**ENVIRONMENTAL STATEMENT –
Addendum, March 2026.**

**NUNEHAM SOLAR FARM – LAND WEST OF A4074, TO THE
NORTH-WEST OF NUNEHAM COURTENAY, SOUTH
OXFORDSHIRE.**

Date: 20/03/2026 | Pegasus Ref: P21-2947

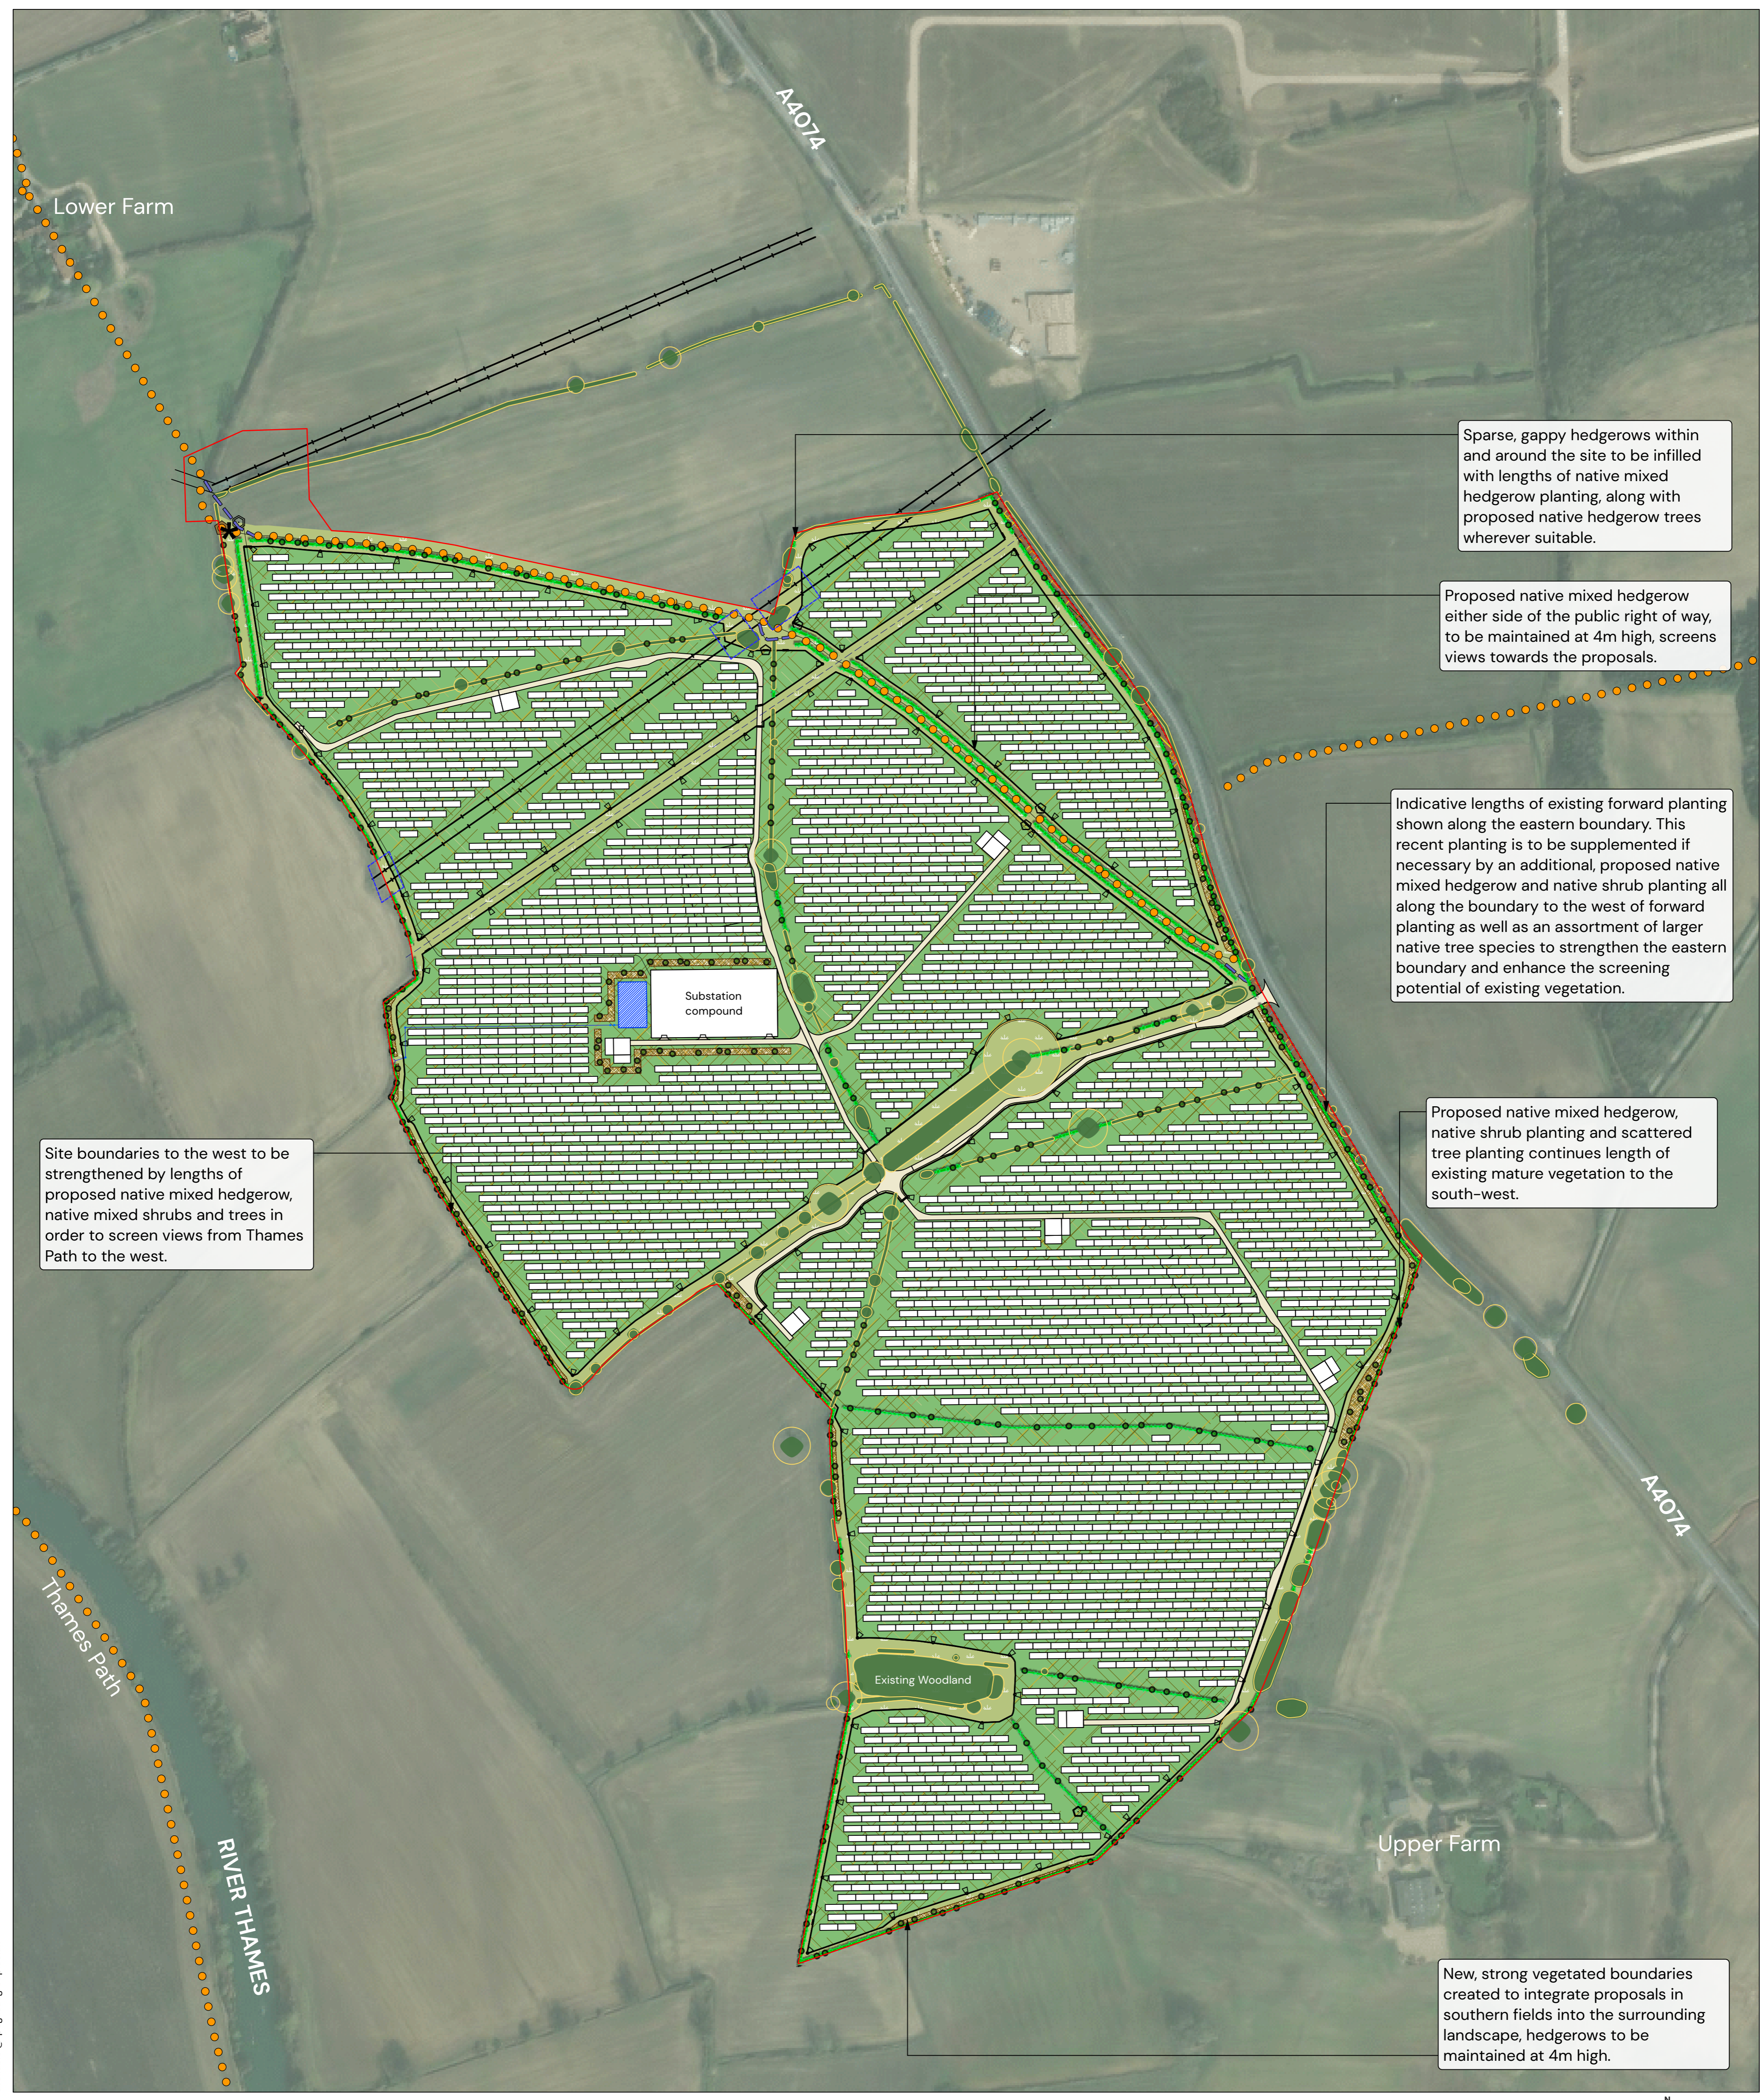
- Figure 6.6 – Landscape Masterplan (now replaced with Drawing Number P21-2947_EN_101_S1 Rev L)
 - Appendix 6.2 – Photographic Record (now replaced with updated version dated January 2026)

Figure 6.6 – Landscape Masterplan, which are designed to further reduce and mitigate effects. In particular this includes for additional trees and new areas of native shrub planting, both around the revised substation location and to the western boundaries of the Site, to further supplement the notable network of additional hedgerows and trees which has already been proposed.

Site boundaries to the west to be strengthened by lengths of proposed native mixed hedgerow, native mixed shrubs and trees in order to screen views from Thames Path to the west.

Sparse, gappy hedgerows within and around the site to be infilled with lengths of native mixed hedgerow planting, along with proposed native hedgerow trees wherever suitable.

Proposed native mixed hedgerow either side of the public right of way, to be maintained at 4m high, screens views towards the proposals.

Indicative lengths of existing forward planting shown along the eastern boundary. This recent planting is to be supplemented if necessary by an additional, proposed native mixed hedgerow and native shrub planting all along the boundary to the west of forward planting as well as an assortment of larger native tree species to strengthen the eastern boundary and enhance the screening potential of existing vegetation.

Proposed native mixed hedgerow, native shrub planting and scattered tree planting continues length of existing mature vegetation to the south-west.

New, strong vegetated boundaries created to integrate proposals in southern fields into the surrounding landscape, hedgerows to be maintained at 4m high.
